UNITED STATES PATENT AND TRADEMARK OFFICE

APPLICATION NO.	FILING DATE	FIRST NAMED INVENTOR	ATTORNEY DOCKET NO.	CONFIRMATION NO.
10/773,033	02/04/2004	Brian Moon	1251.185	5698

Office Action Summary	Application No. 10/773,033	Applicant(s) MOON ET AL.	
	Examiner Timothy M. Ayres	Art Unit 3637

This is a first office action on the merits of application SN 10/773,033.

Hsu '759 Figure 1

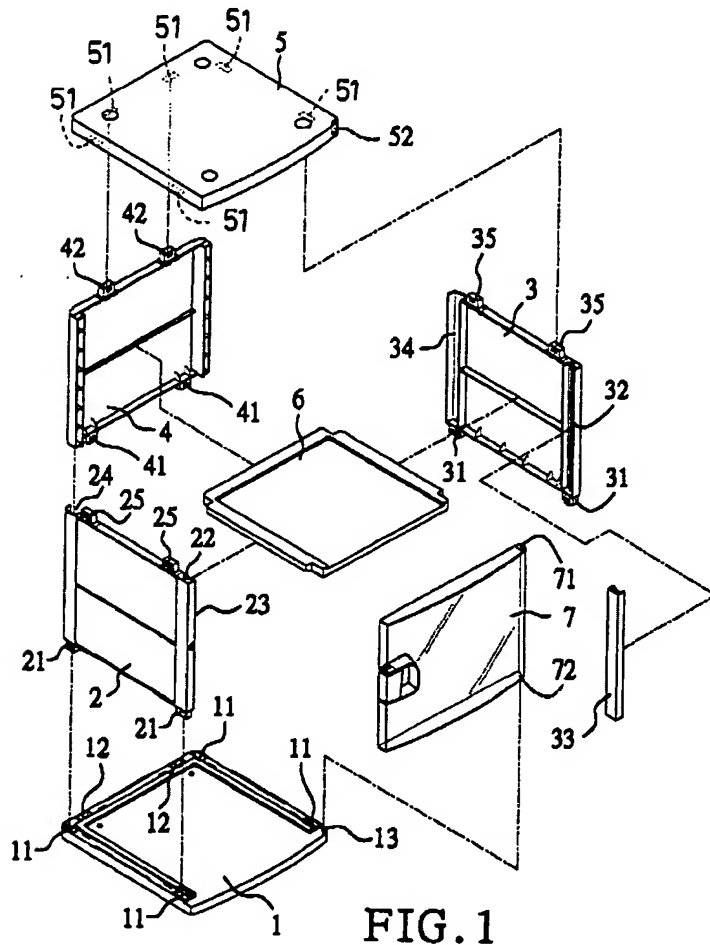
11. Claims 1, 2, 11-16 are rejected under 35 U.S.C. 103(a) as being unpatentable over US Patent 6,474,759 to Hsu in view of US Patent 4,193,649 to Sharon. Hsu teaches a plastic cabinet that can have drawers as seen in figure 11. The cabinet is made up of a base panel (1), top panel (5), left side panel (2), right side panel (3), and back panel (4). The top and bottom panels (1,5) connect to the side and back panels (2,3,4) with a means for attaching (11, 12 ,51, 21,25,41,42,31,35). The means for

attaching (11, 12, 51, 21, 25, 41, 42, 31, 35) is posts (35, 42, 25, 21, 31, 41) on the side and back panels (2, 3, 4) that have integrally formed spring tabs (A') that communicate with locking sockets (11, 12, 51) in the base and top panels (1, 5) as seen in figure 1 and 7 below.

Sharon '649 Figure 4

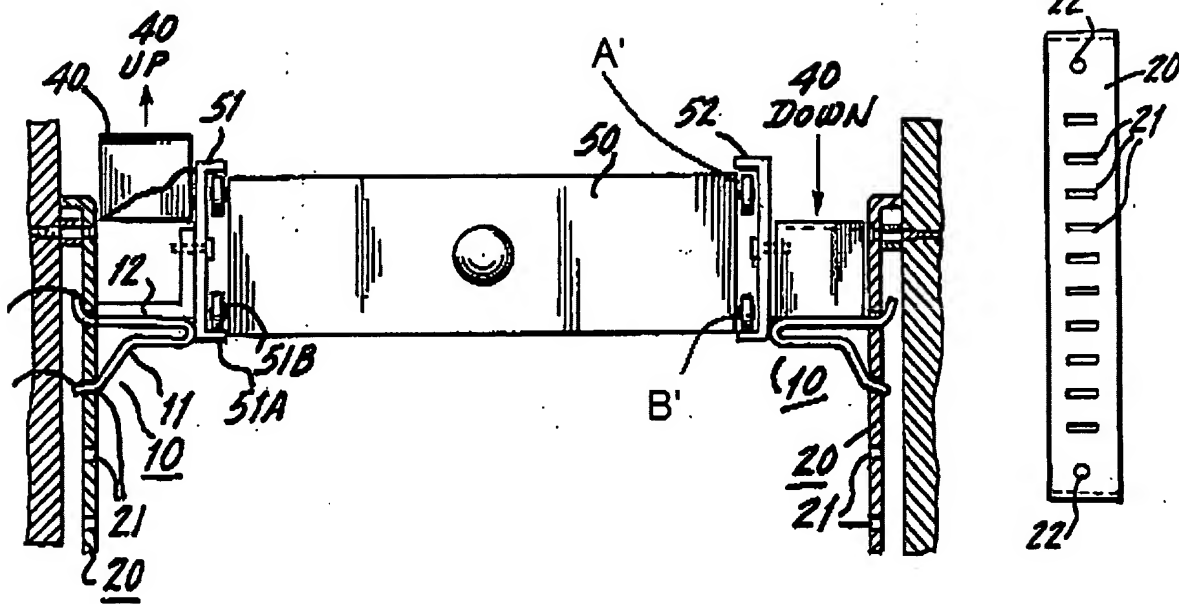
drawer glide system that includes drawer glides (51, 52) that have clips (10) to insert into apertures (21) on a vertical rail (20). This system allows for different sized drawers to be used in the cabinet. (Col. 1, lines 39-44). The drawer has an upper and lower roller (A', B') to engage with the drawer glide (51, 52). At the time of the invention it would have been obvious for a person of ordinary skill in the art to modify the cabinet of Hsu by adding the vertical rails and drawer glide structure as taught by Sharon to allow for adjustable drawers (Sharon '649, Col. 1, lines 39-44)

Hassel '874 Figure 3

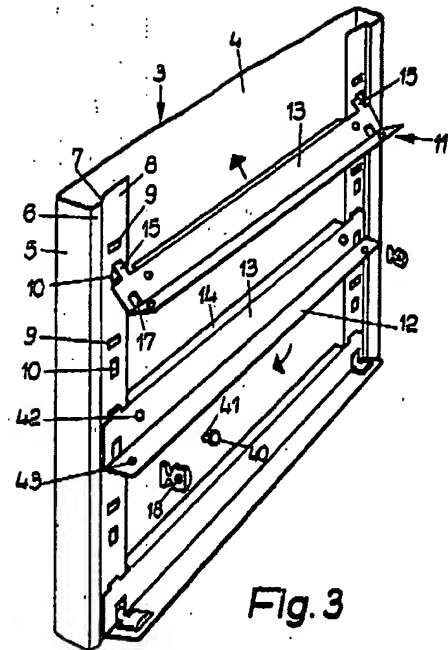
16. Hassel teaches a cabinet (1) with drawers (2). The drawer glides (11) are mounted with locking posts (16,15) that have a conjugate shape and extend through apertures (9) in integral vertical rail (8) that are formed on the side wall (3). The drawer glides (11) are L-shaped with a vertical leg (13) and horizontal leg (12). The drawers (2) have slides (34,35) and the rear portion of the drawer (2). A locking member (18) extends through an opening (17) in the vertical leg (13) of the drawer glide (11) and an aperture (10) on the vertical rail (8) to secure the drawer glide (11) in place. The upper slides (35) contact the bottom of the drawer glide (11) that is above the drawer (2) and the lower slides (34) on the drawer (2) contact a drawer glide (11) that is relatively level with the drawer (2).

Schenker '340 Figure 5

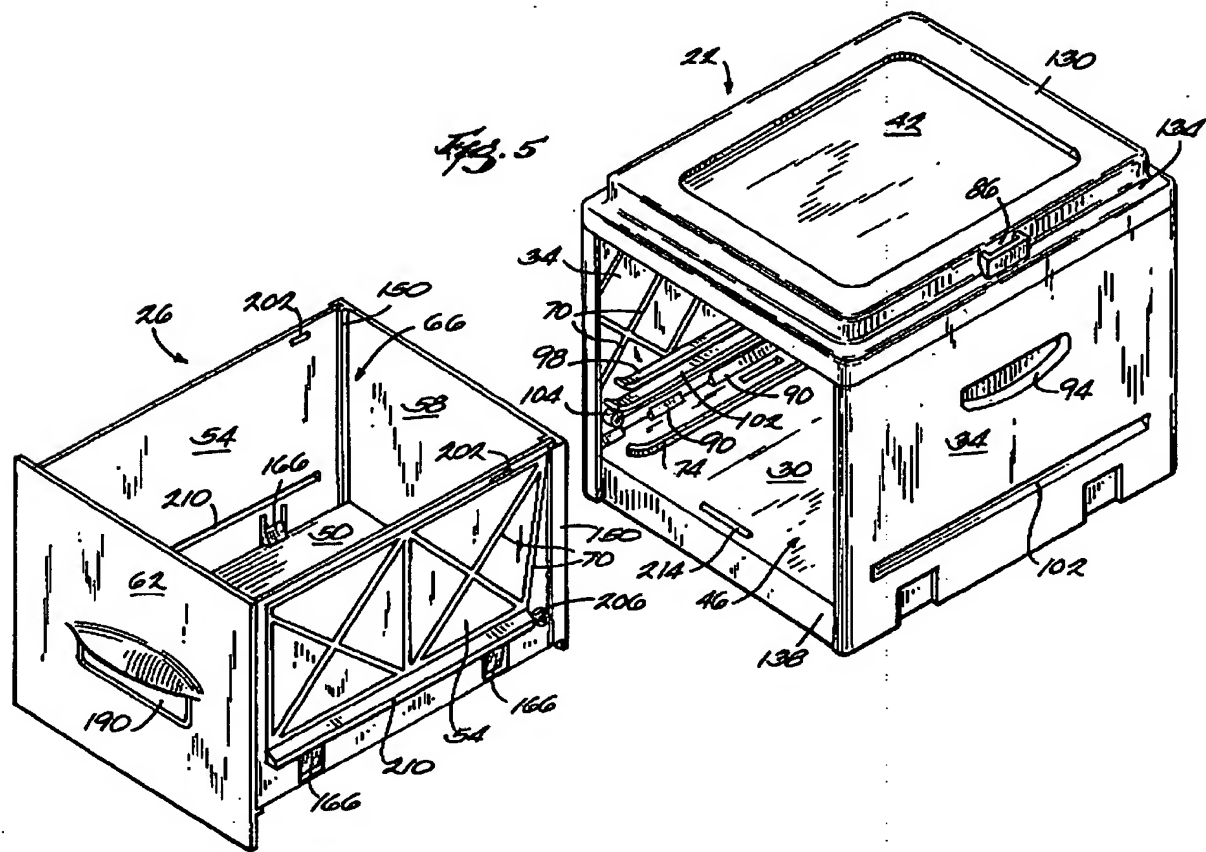
19. Schenker teaches a plastic drawer cabinet (10) that has rollers (206) integral connected to the side (54) of the drawer to allow the drawer (26) to slide easier. A roller

(104) is integrally formed at the front portion of the drawer glide (102) to allow the bottom of a portion (210) of the drawer (26) to slide upon the roller (104). Cross braces (70) are formed in the sidewalls (54) of the drawer (26) to help strengthen it.

Rechberg '734 Figure 3

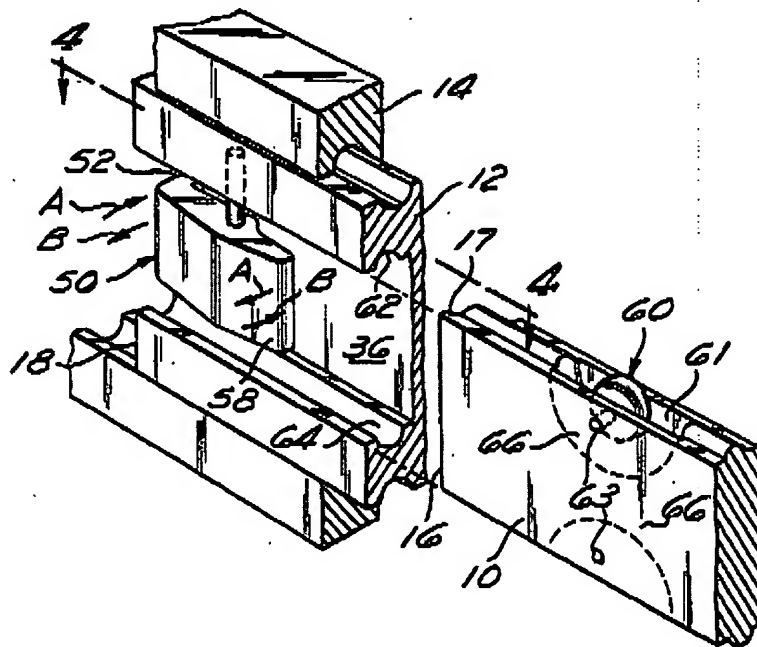
6,193,340 to Schenker as applied to claims 1, 3, and 6 above, and further in view of US Patent 4,872,734 to Rechberg. Hsu in view of Hassel and Schenker discloses every element as claimed and discussed above except the rollers positioned in integrally formed pockets. Rechberg teaches a drawer slide mechanism that uses rollers (60). The rollers (60) are mounted via a pin (63) in a pocket (61) formed on a slide member (10). At the time of the invention it would have been obvious for a person of ordinary skill in the art to modify the drawer cabinet of Hsu in view of Hassel and Schenker by forming a pocket in the upper and lower portion of sides of the drawer cabinet for the roller to sit as taught by Rechberg so that drawer promotes smooth, low-friction, noise-free movement (Rechberg '734, Col. 2, lines 5-10).
